# GTE SYLVANIA

## TECHNICAL SERVICE DATA

STEREO HI-FI  
SUPPLEMENT 4 TO  
BULLETIN: R74-3

Table lists all code changes to date on the R74-3,-4 chassis.

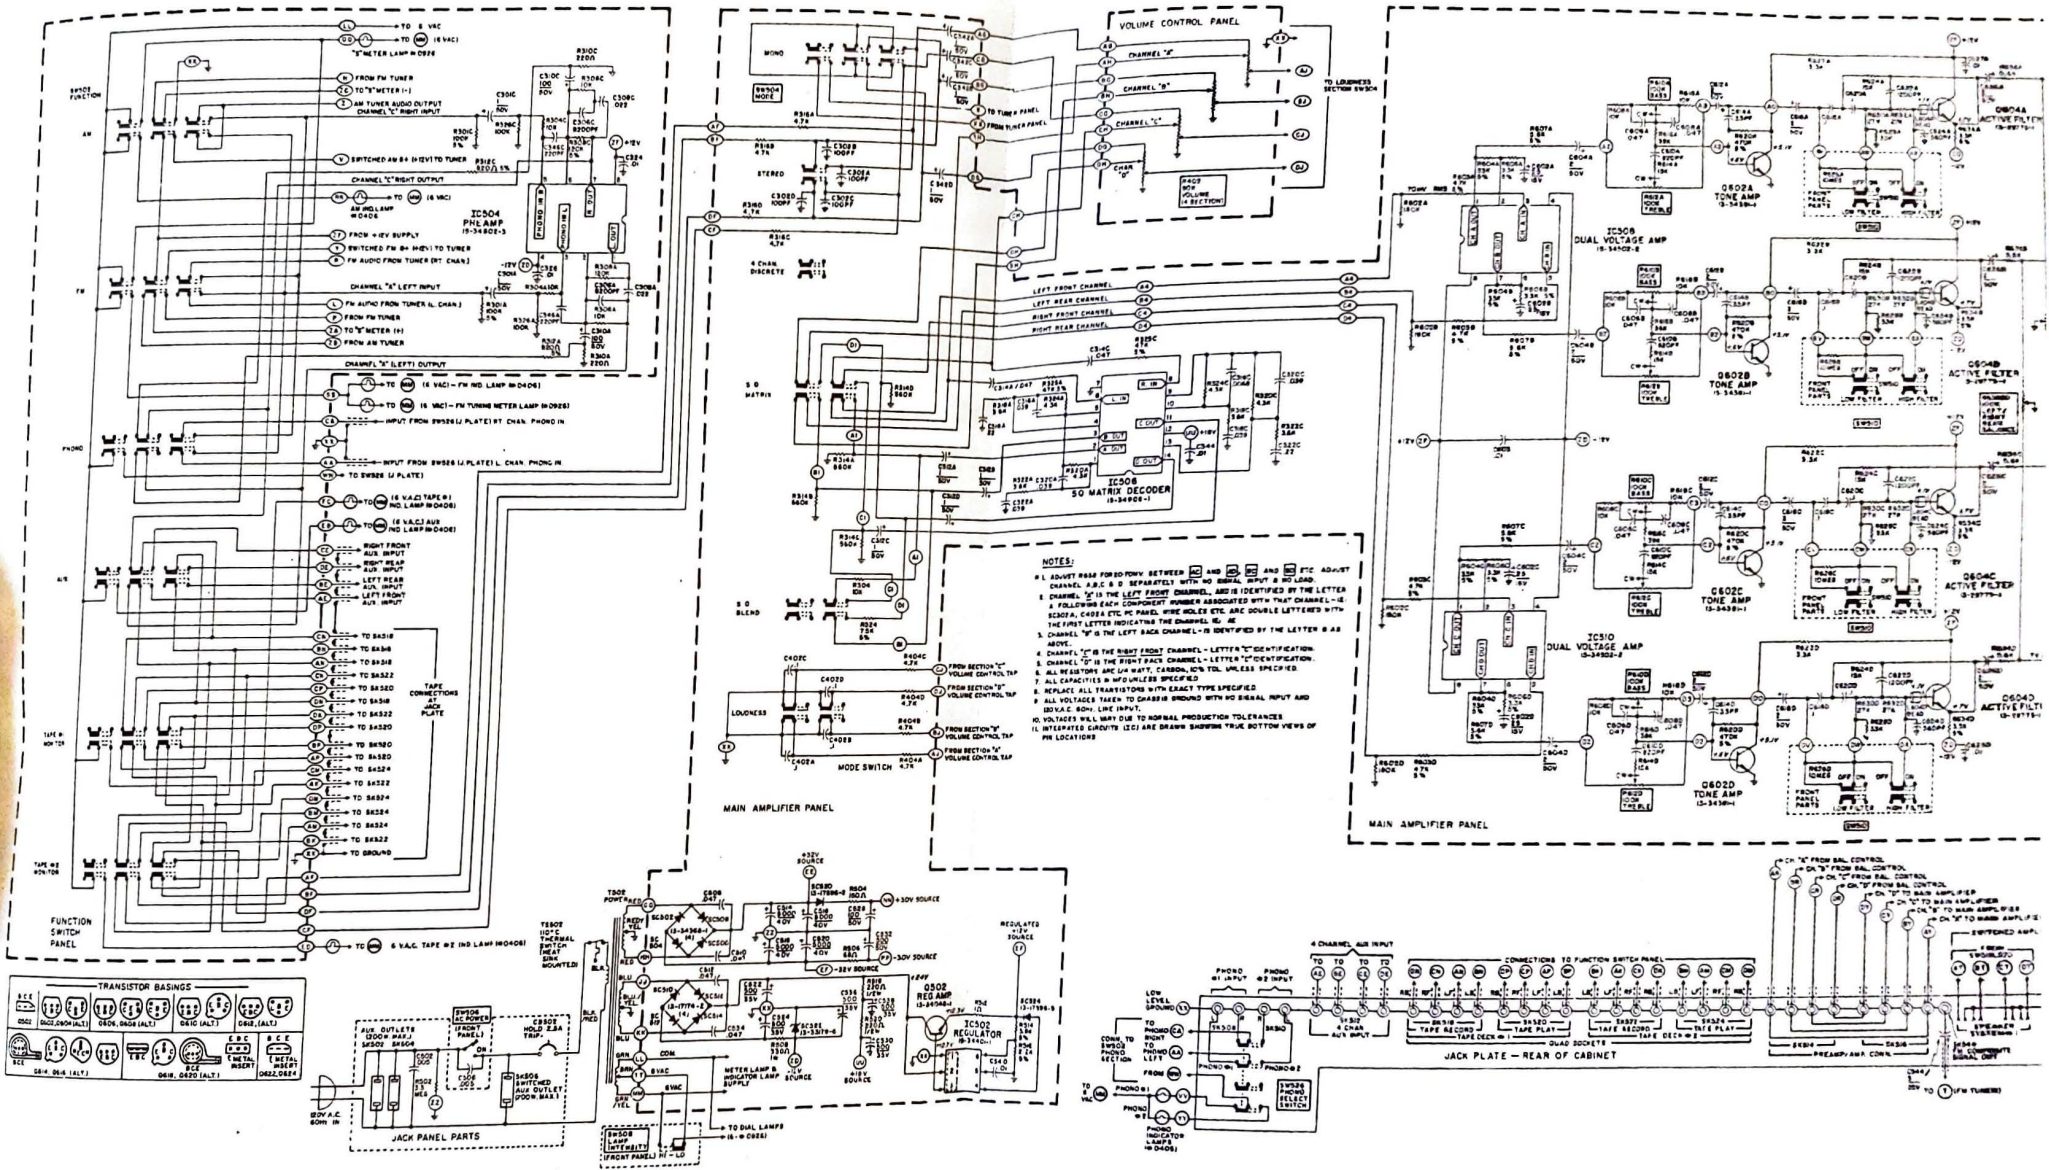
CODE	CHASSIS	PANEL CODE	DESCRIPTION OF CHANGE
00	ALL	-	INITIAL PRODUCTION.
01	-3		POWER AMPLIFIER OSCILLATION.
01	-4		1) 33pF, N150 capacitors added from Base to Collector of Q606 A,B,C,D on foil side of P/C panel.
02	-3		MULTIPLEX SEPARATION DEGRADES WITH TEMPERATURE CHANGE. 1) Cores replaced in T4 and T6.
02	-4	A	CHASSIS IDENTIFICATION ONLY. To provide a means to identify finished goods built with SQ chips with date codes of 7331 and 7332.
02	-4	B	IMPROVED SPEAKER PROTECTION. 1) CB602 replaced by 02-36800-1 relay panel. 2) C629 removed. 3) R640 removed. 4) C632 value changed to 3.3pF. 5) R639 value changed to 220K. 6) R648 value changed to 10K.
03	-3	-	RELAY TRIPS WHEN TUNING ACROSS FM BAND. (02-36800-1 PANEL REVISION). 1) C1204 value changed to 100MFD/15V - new part number is 41-32477-37. NOTE: All CODE A relay panels with this change prior to CODE B are identified by a RED STRIPE through the identification sticker.

TO COMPLY WITH IHF AND INDUSTRY STANDARDS. 1) BLUE/WHITE/, RED/WHITE, BLUE and RED leads reversed on headphone jacks.  The industry standard is for LEFT channel audio to the TIP of the headphone plug, and RIGHT channel audio to the RING of the plug.

SCHEMATIC DIAGRAM (R74-3 AMPLIFIER)

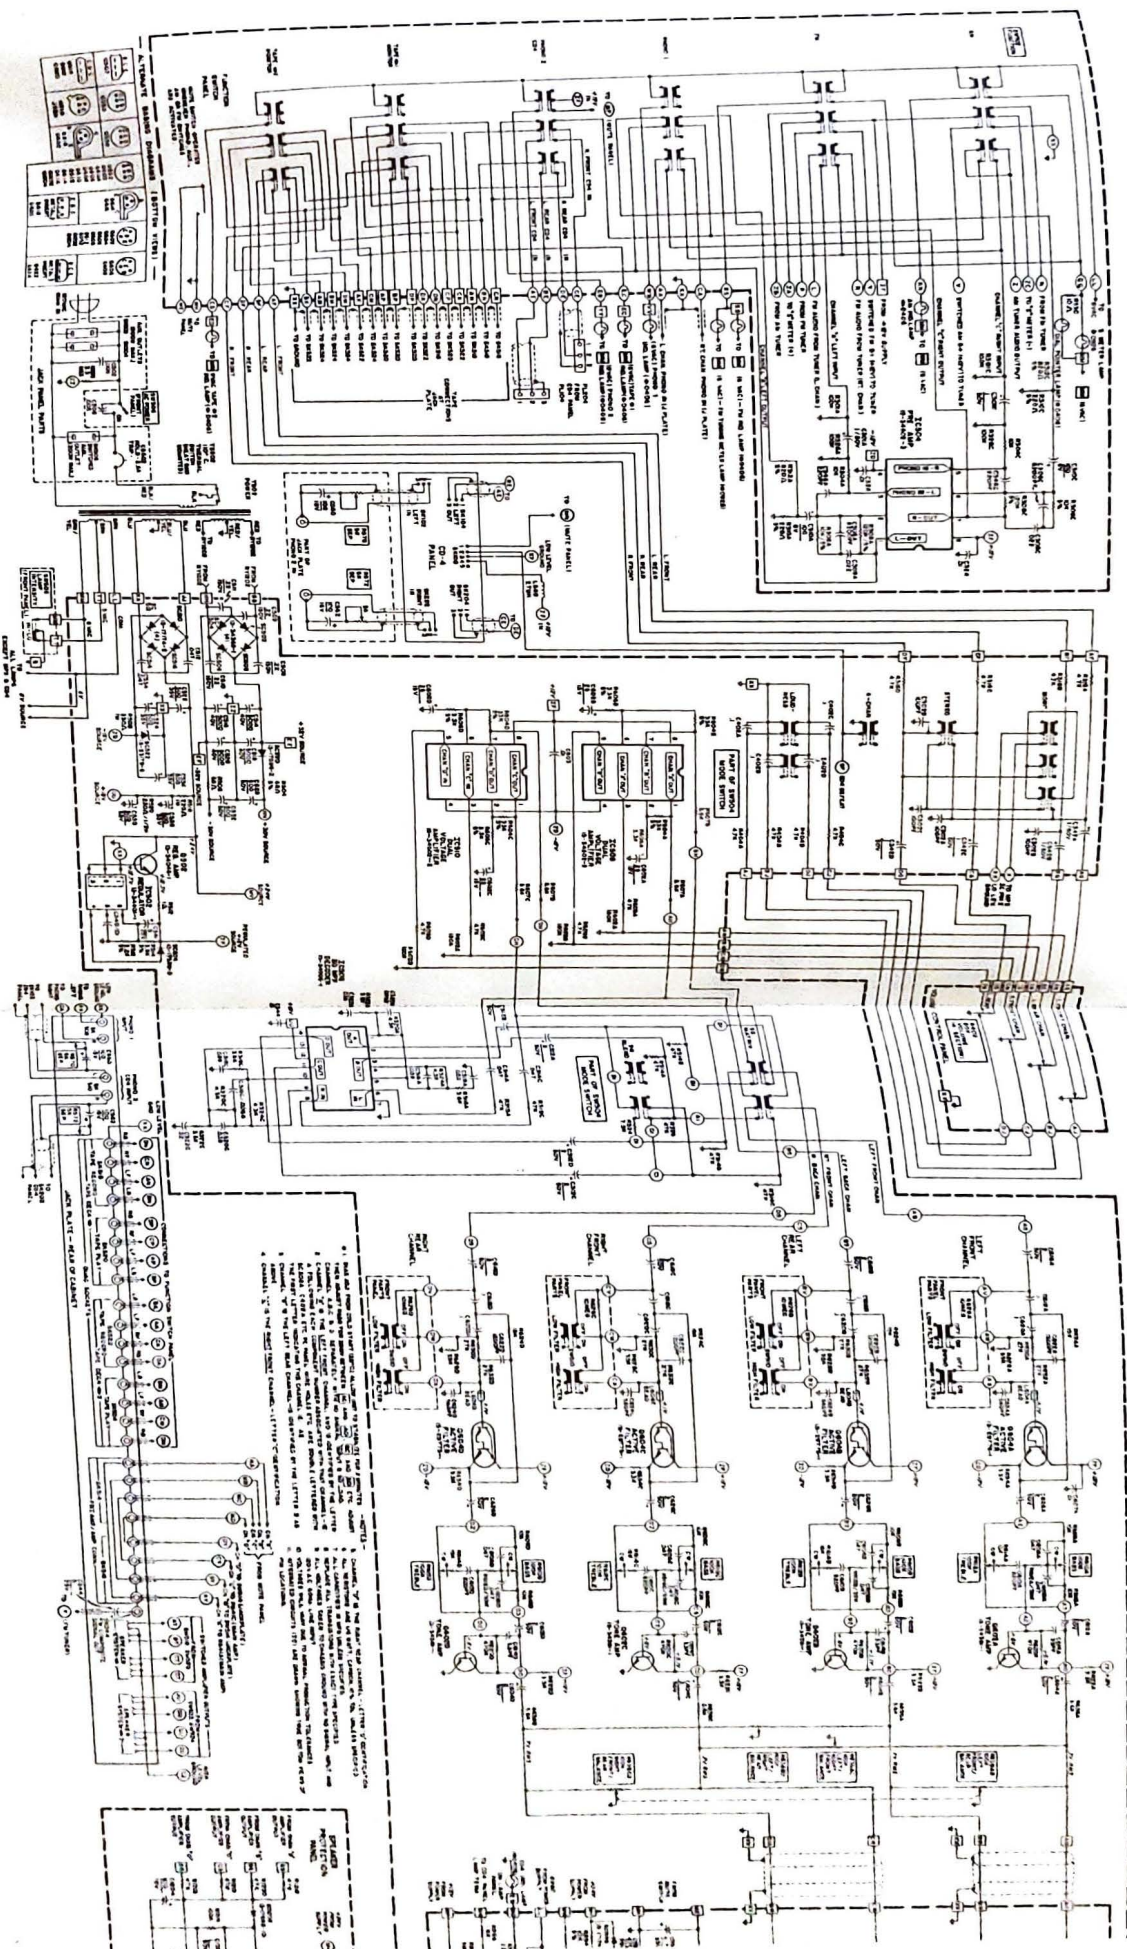
CODE	CHASSIS	PANEL CODE	DESCRIPTION OF CHANGE
03	-4	B	<p>POWER AMP NOISE PICKED UP IN AM MODE.</p> <ol style="list-style-type: none"> <li>1) C114 value changed to .05, 50V.</li> <li>2) C529 (.22, 150V) added from amplifier end of +32V buss to ground on foil side of P/C panel.</li> <li>3) C629 (10pF, NPO) added between Base and Collector of Q606 on foil side of panel.</li> </ol>
04	-3	-	<p>RF PICK-UP IN PHONO PREAMP</p> <ol style="list-style-type: none"> <li>1) C304 removed.</li> <li>2) C346A (1000pF, Z5P) added between pins No. 2 &amp; 3 of IC504.</li> <li>3) C346C (1000pF, Z5P) added between pins No. 5 &amp; 6 of IC 504.</li> </ol> <p>TO ELIMINATE POP WHEN SWITCHING FROM FM TO AM.</p> <ol style="list-style-type: none"> <li>1) C46 removed.</li> <li>2) R302A, C removed.</li> <li>3) R326A, C value changed to 100K.</li> <li>4) R63 (100K, 5%) added from wire hole L1 to ground.</li> <li>5) R65 (100K, 5%) added from wire hole R1 to ground.</li> <li>6) R149 (100K, 5%) added from square wire pin Z to ground.</li> <li>7) R301A (100K, 5%) added from + end of C301A to ground.</li> <li>8) R301C (100K, 5%) added from + end of C301C to ground.</li> </ol> <p>TO ELIMINATE POP WHEN SWITCHING FROM FM TO PHONO.</p> <ol style="list-style-type: none"> <li>1) C72 value changed to 1MFD/50V.</li> <li>2) C74 value changed to 1MFD/50V.</li> </ol> <p>TO FACILITATE BOARD ASSEMBLY.</p> <ol style="list-style-type: none"> <li>1) C108 (10MFD/15V Electrolytic) added from junction of R112, R114 to ground.</li> <li>2) Q604 part number changed to 13-29775-1.</li> </ol> <p>TO REDUCE SWITCH POP.</p> <ol style="list-style-type: none"> <li>1) C604 value changed to 2MFD/50V.</li> <li>2) R314 value changed to 47K, 5%.</li> <li>3) R607 value changed to 5.6K, 5%.</li> <li>4) R620 value changed to 470K, 5%.</li> <li>5) R634 value changed to 3.3K, 5%.</li> </ol>

04	-4	B	<p>FET RELIABILITY IMPROVEMENT.</p> <ol style="list-style-type: none"> <li>1) Q2 part number changed to 13-34378-3.</li> </ol>
